**Town of Southern Pines Planning Board Regular Meeting
Douglass Community Center
January 20, 2022 at 6:00 PM**

Subject: PD-12-21: Planned Development - Preliminary Development Plan for Phase 1 of the Waterworks mixed-use development; Applicant: Andy Bleggi, PTAH Corporation; Authorized Agent: Kevin Lindsay of Crawford Design.

Date: January 20, 2022

Subject: PD-13-21: Planned Development - Preliminary Development Plan for the new development of a retail building; Applicant: Ubuntu Developer LLC, Sanjeev Bhunta; Authorized Agent: Kevin Lindsay of Crawford Design Company

PRELIMINARY PLAN

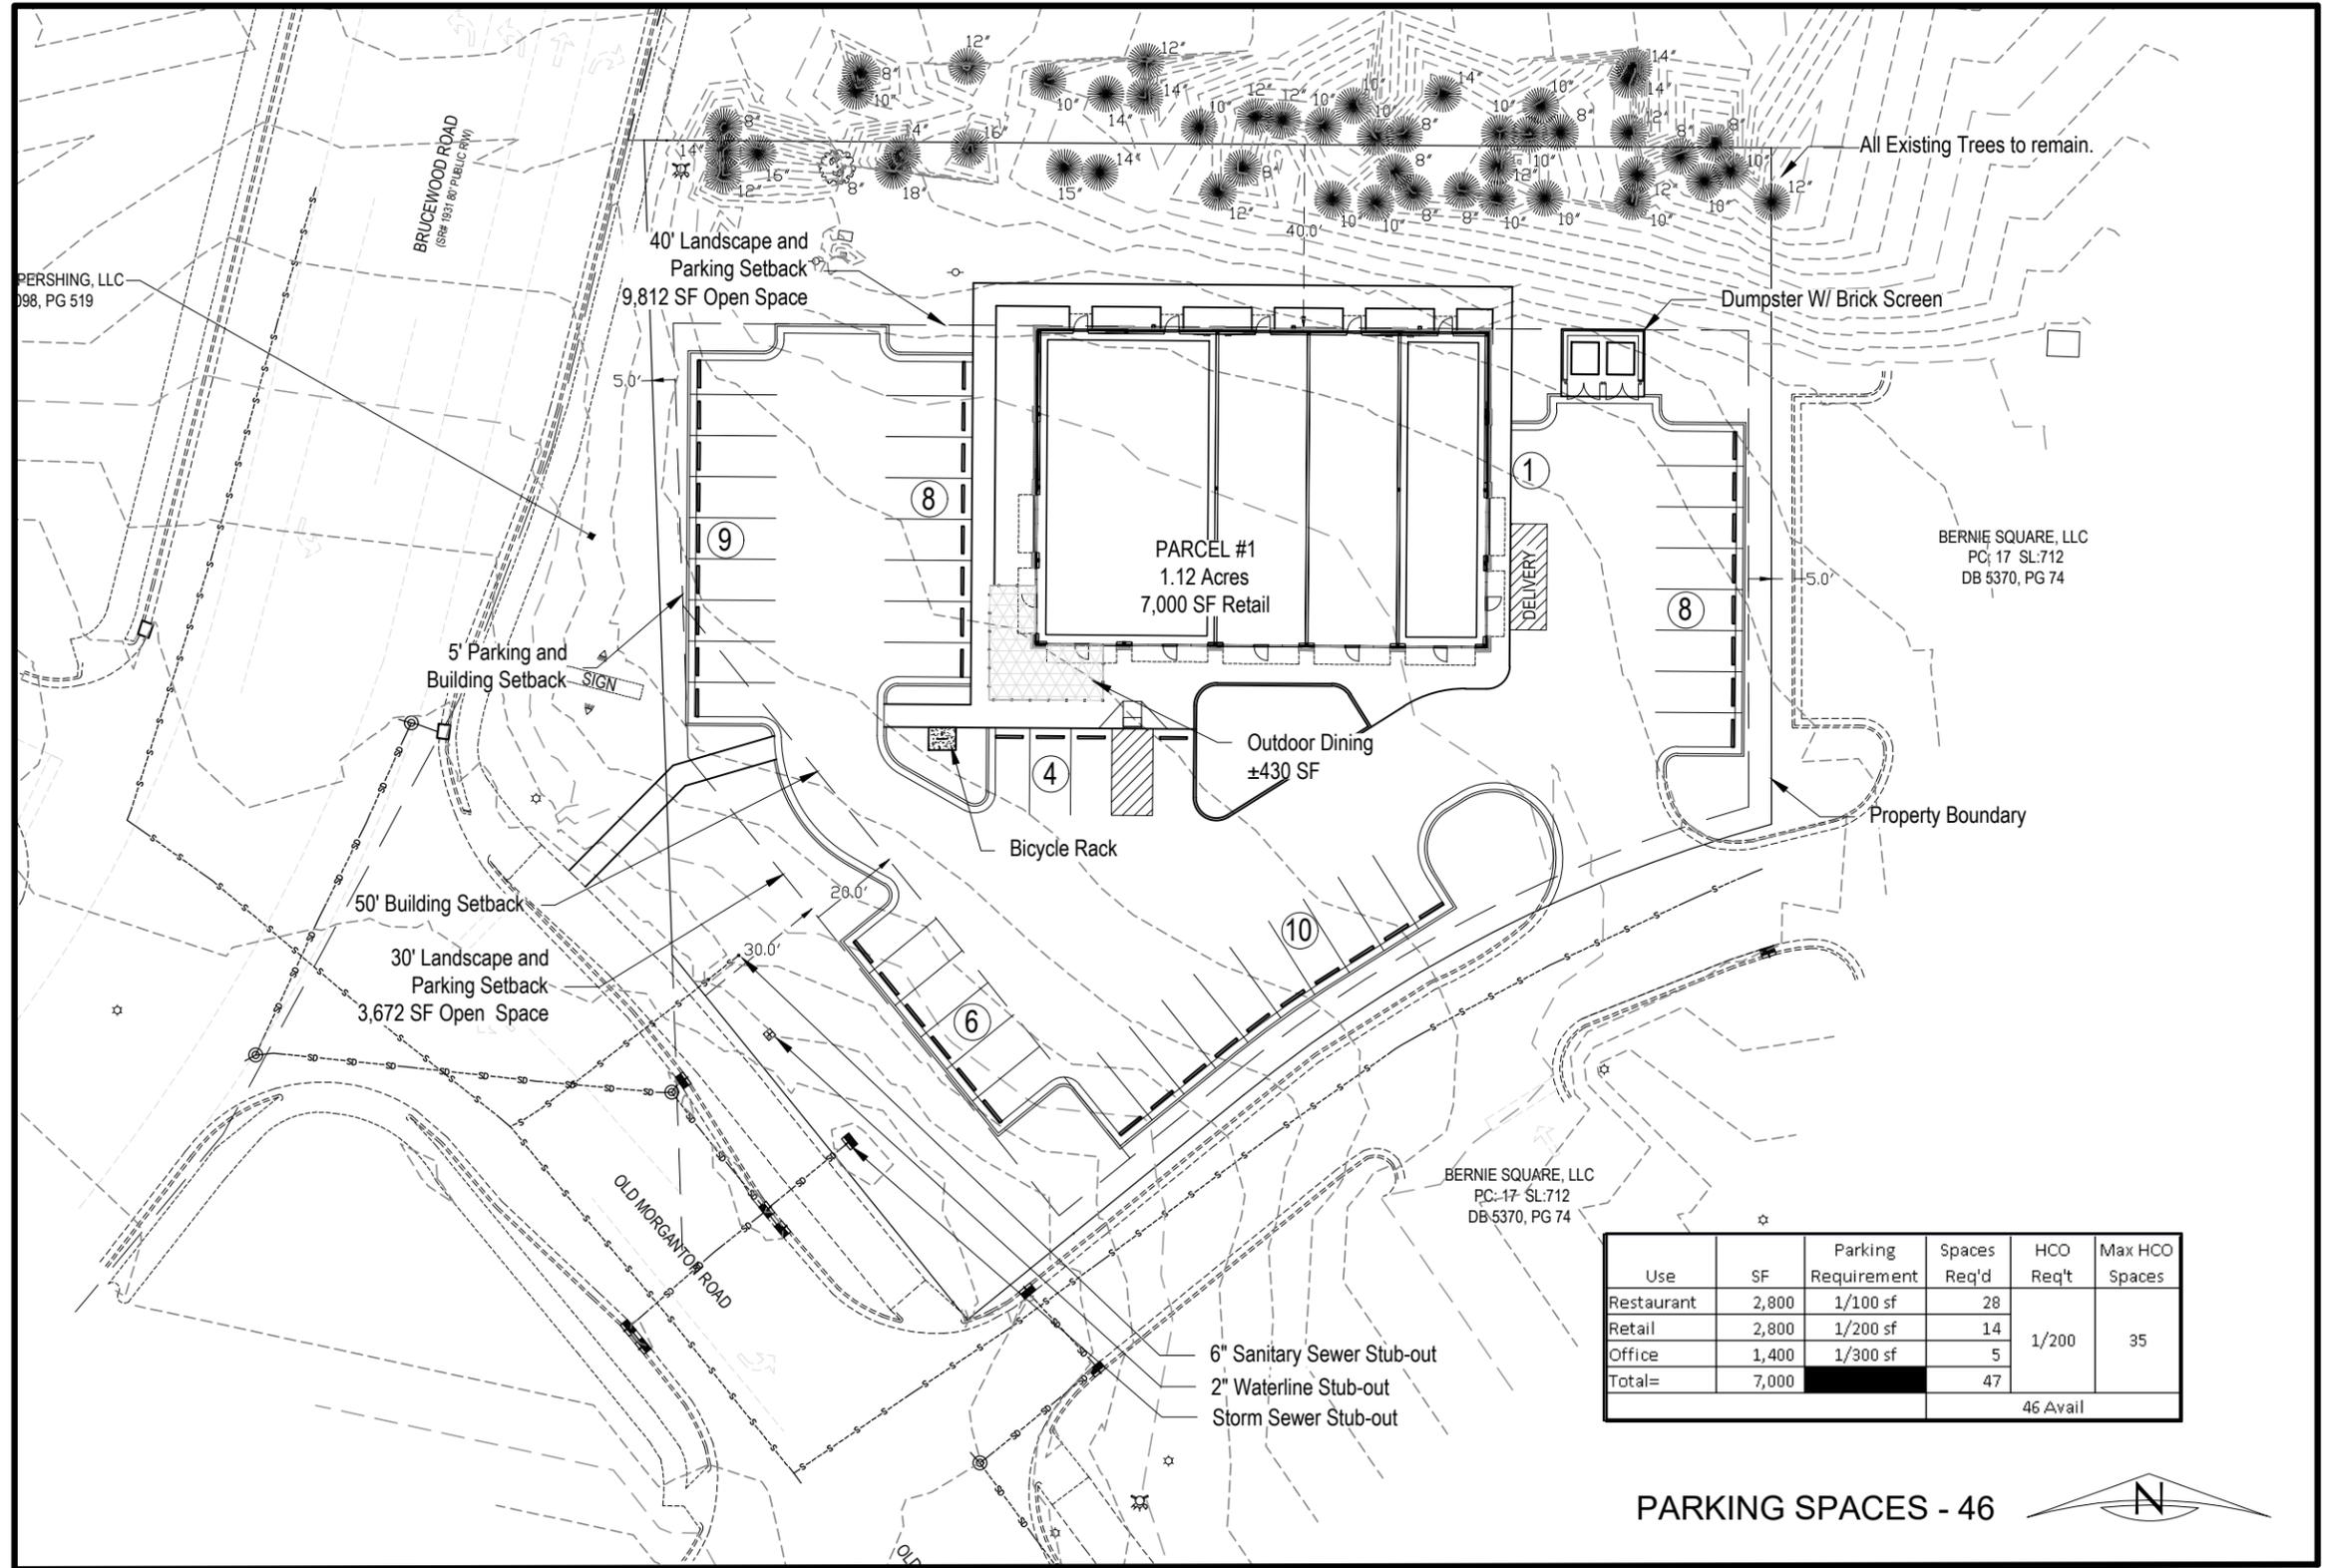
- The applicant is requesting a modification to allow up to 46 parking spaces, which is in excess of the maximum number of parking spaces allowed within the Urban Village Road Highway Corridor Overlay District (UVHCO). The UVHCO requires that the number of parking spaces shall be a maximum of one space per 200 square feet of gross floor area. This equates to a maximum of 35 parking spaces for a 7,000 square foot retail building. The proposed development plan proposes parking for 46 vehicles, or one space per 150 square feet of gross floor area. The applicant has provided a parking waiver request and it is included in the attachment portion of the staff report.
